8922G-01

S E R V I C E N O T E SUPERSEDES: None

Recommended Removal of Hardware

FIGURE 1 Top Internal View of HP 8922A/B/E/G

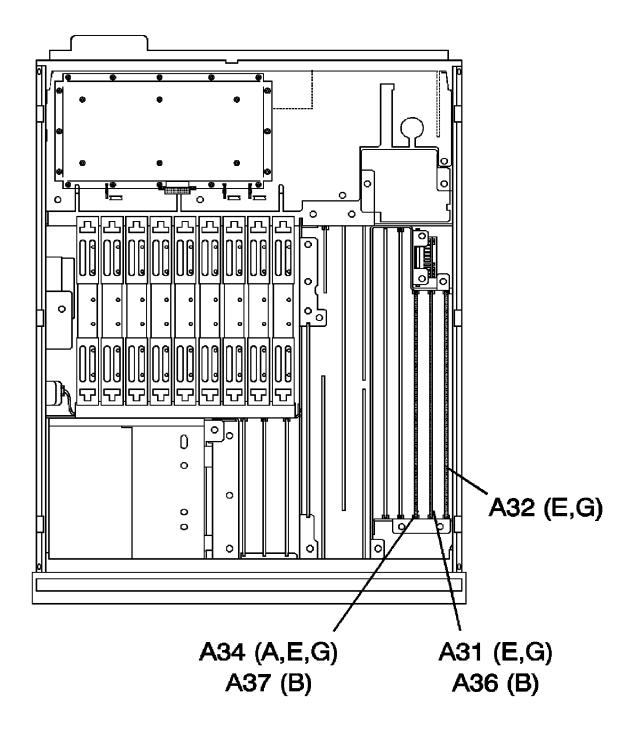
Instruments with serial numbers noted above may have internal hardware (screw and nut) which is improperly attached to the A31 GSM CODEC, A32 GSM Controller, and A34 GSM RTI assemblies. Refer to Figure 1 for location of these assemblies. The hardware can become separated from the assembly, contact other circuitry and may cause electrical damage.
